1.问题点Question

3.问题点question

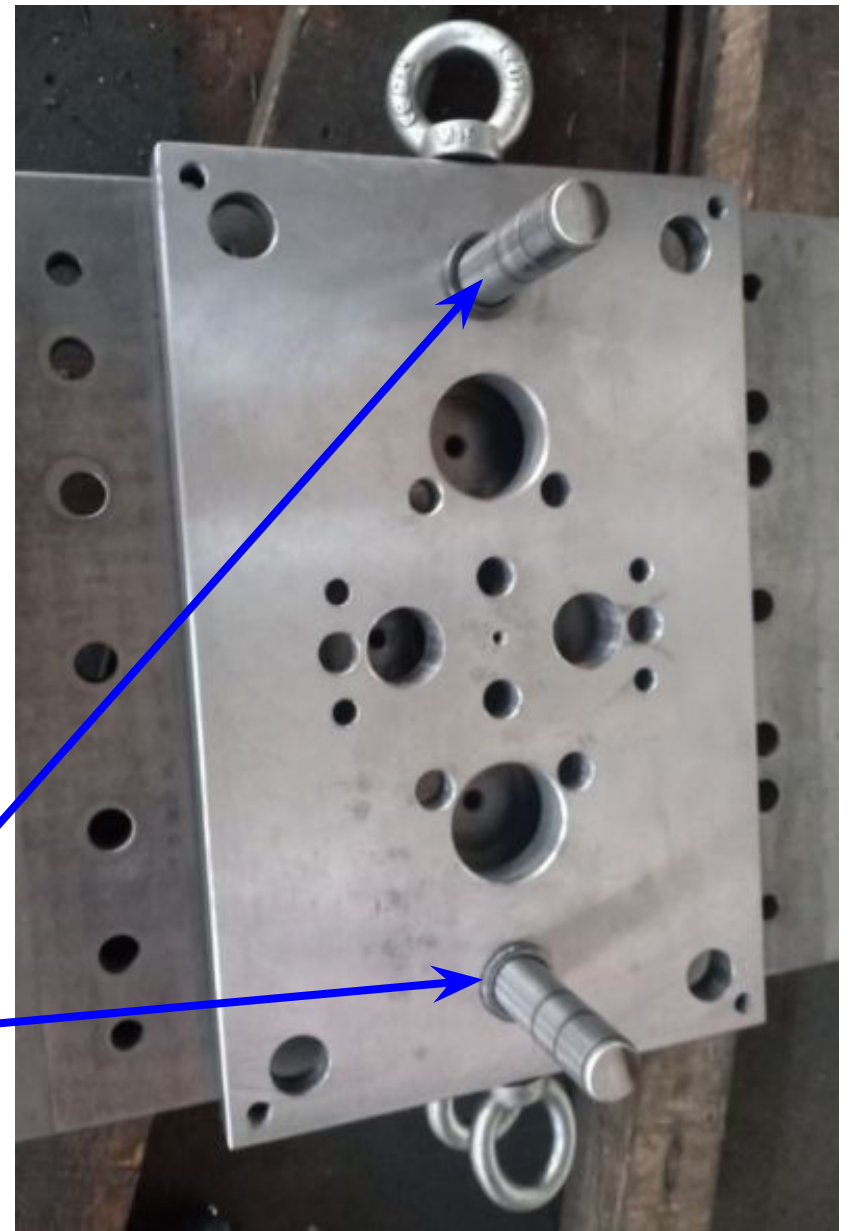
There was no EGP on the mold before, and the mold ejection was unbalanced. We have added 2 EGPs. Please know.

4.问题点Question

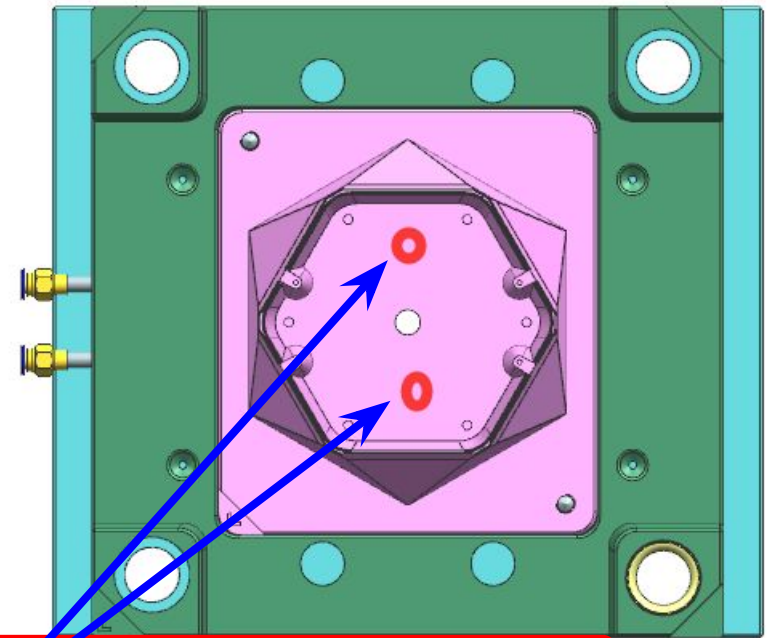
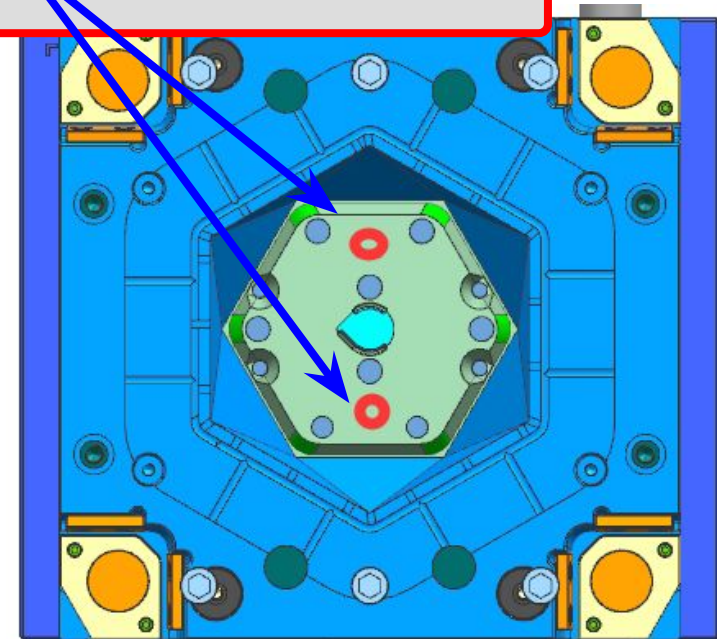
Due to difficulty in ejecting the product, it is recommended to add 2 air pins to the front and rear molds to assist the ejection of the product. (As shown in the red area)

To solve the above problems from 2-4 points: increase the air pins, replace the template, increase EGP, etc., mold repair cost: 380USD, please refer to the quotation for details.

5.问题点 Question

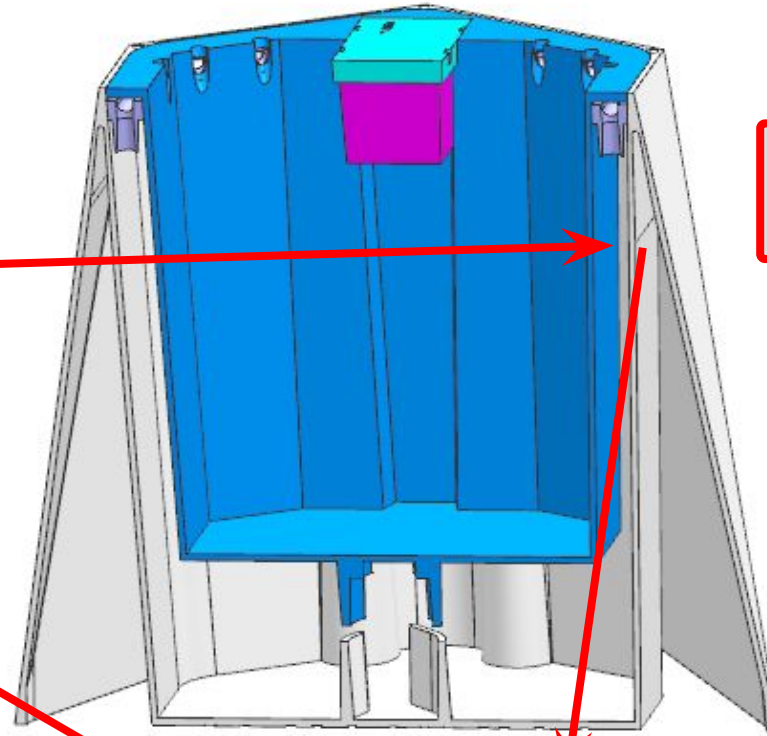
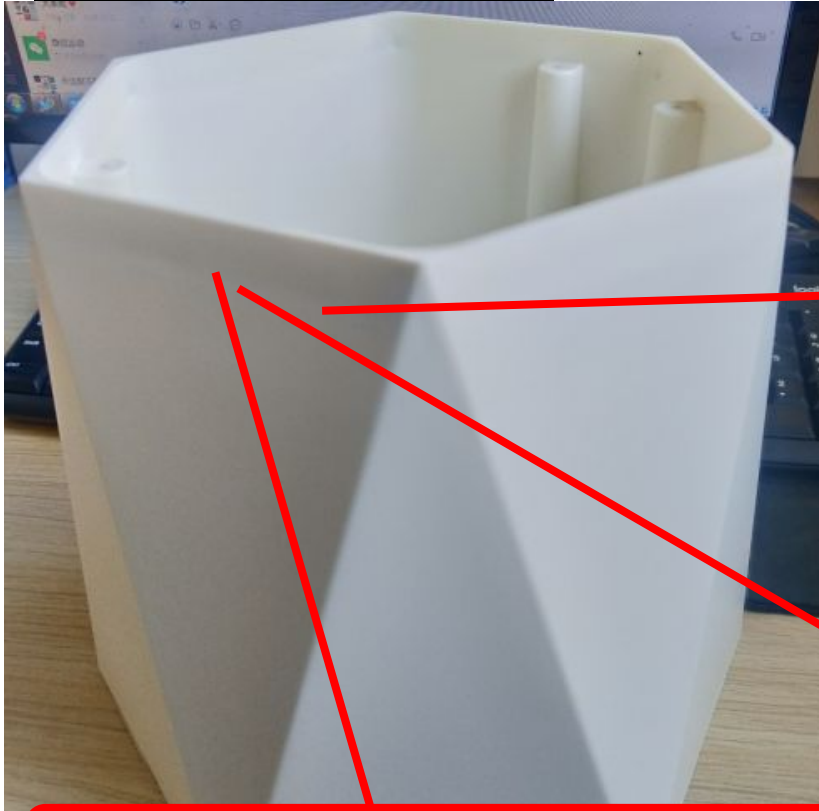
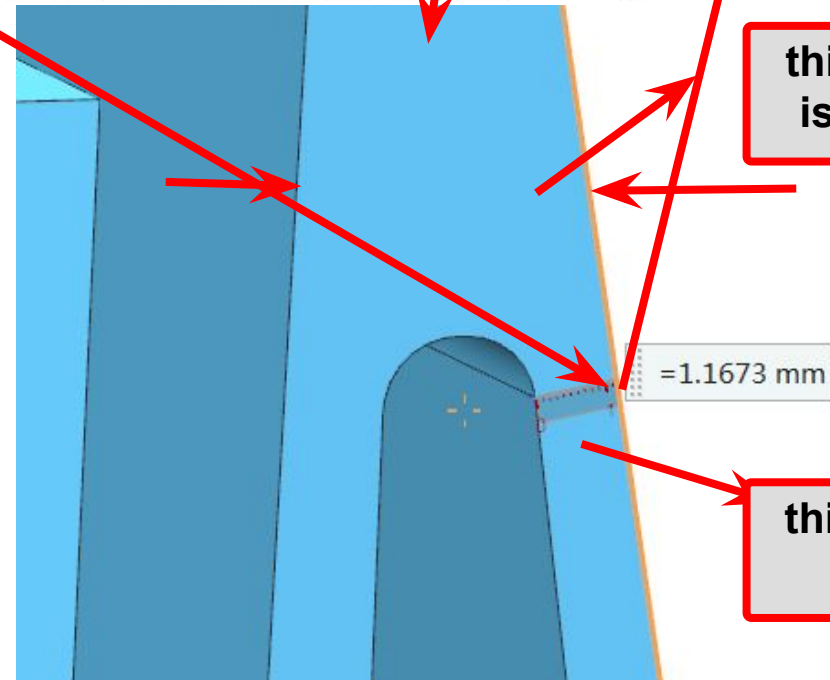
there is line
around of top

We will try to increase the thickness on the side of the product to solve the problem of shadow lines caused by uneven product thickness. However, it cannot be guaranteed to be completely no line, because it cannot be increased too thick, and the outer side may cause shrinkage problems if it is too thick. This is a contradiction question.
